Access Compliance Report

Public Rights-of-Way

(Curb Ramps)

Intersection ID: 7969	Main Street: BROOKSHIRE_BV	Cross Street: N_HOSKINS_RD	Location: SE
ADA ID: 14143C095929	Ramp Type: Para	Initial Pass/Fail: Fail	Overall Compliance: No
Severity Score: 13.75			
Codes/Mitigation Info/Possible Solution		Field Measurements/Component Compliance

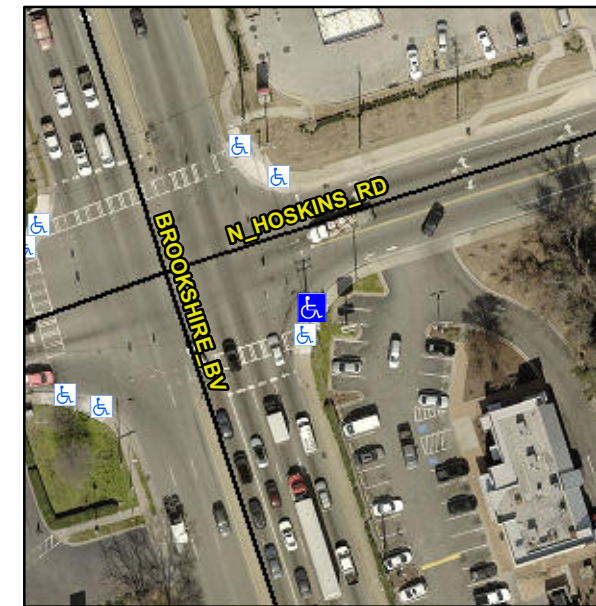
RT RP < 5%

R304.3.2, R304.5.3

Compliance	Description	Data	Compliance	Description	Data
N/A	Ramp Length LT (in)	67.0	N/A	Ramp Length RT (in)	62.0
Yes	Ramp Width LT (in)	70.5	Yes	Ramp Width RT (in)	70.5
No	Ramp Slope LT (%)	11.8	Yes	Ramp Slope RT (%)	1.5
No	Ramp XSlope LT (%)	2.7	Yes	Ramp XSlope RT (%)	1.2
N/A	Landing Length (in)	N/A	N/A	DWS Provided?	N/A
N/A	Landing Width (in)	N/A	N/A	DWS Contrast?	N/A
N/A	Landing Slope (%)	N/A	N/A	DWS Length (in)	N/A
N/A	Landing X Slope (%)	N/A	N/A	DWS Full Width?	N/A
N/A	Landing Curb? (Y/N)	N/A	N/A	DWS Offset (in)	N/A
N/A	Shared Landing?	N/A			
N/A	Gutter Ponding?	N/A	N/A	Gutter Slope (%)	N/A
N/A	Gutter Lip Ht (in)	N/A	N/A	Gutter X Slope (%)	N/A
N/A	Painted X Walk1?	Yes	N/A	Painted X Walk2?	N/A
	X Walk 1 Direction	To N		X Walk 2 Direction	N/A
N/A	X Walk 1 Width (in)	111.0	N/A	X Walk 2 Width (in)	N/A
	X Walk 1 Slope (%)	7.7		X Walk 2 Slope (%)	N/A
	X Walk 1 X Slope (%)	2.1		X Walk 2 X Slope (%)	N/A
N/A	Ramp inside XWalk1?	Yes	N/A	Ramp inside XWalk2?	N/A

Remove & Replace Entire Ramp.
